BHPC MEETING PACKET

Amended January 27, 2022

Thursday January 27, 2022

REAR PERSPECTIVE

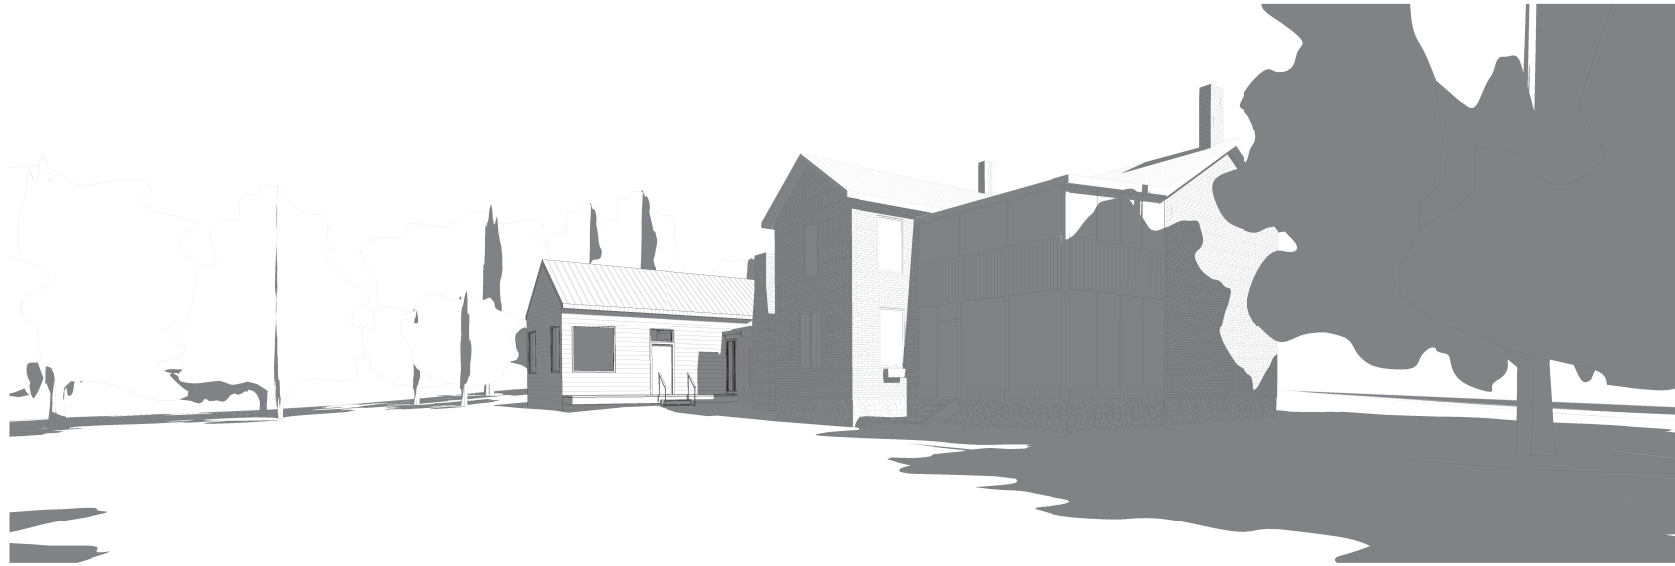
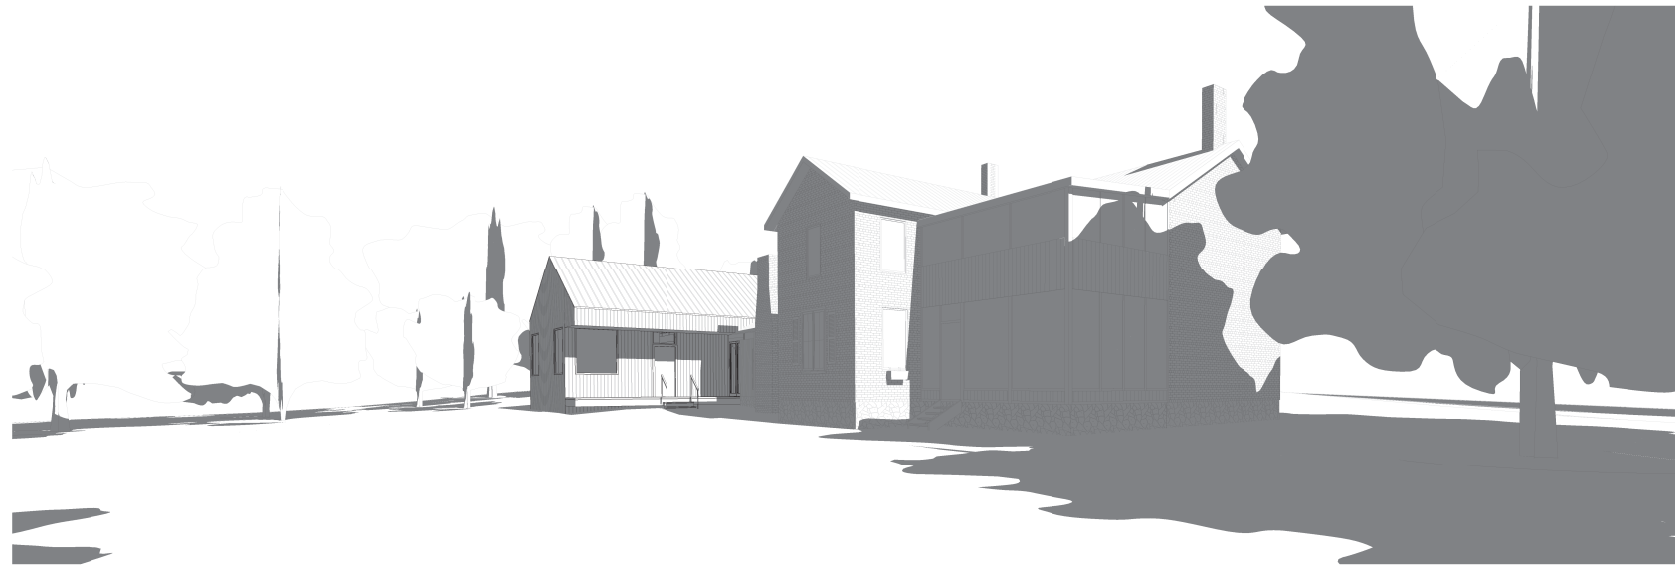
Background:	The Reverend James Faris House Historic District
Request:	Partial demolition, stabilization of foundation, and new construction.
Guidelines:	The Secretary of the Interior’s Standards for the Treatment of Historic Properties
Staff Recommendation: Approval of COA 22-03, option 2	
The petitioner revised the addition design to incorporate the feedback received from the HPC on the Jan. 13, 2022 meeting. The proposed garage has been set back, option 1 reflects a smaller roof proportion but option 2 provides a roofed entrance to the extension.
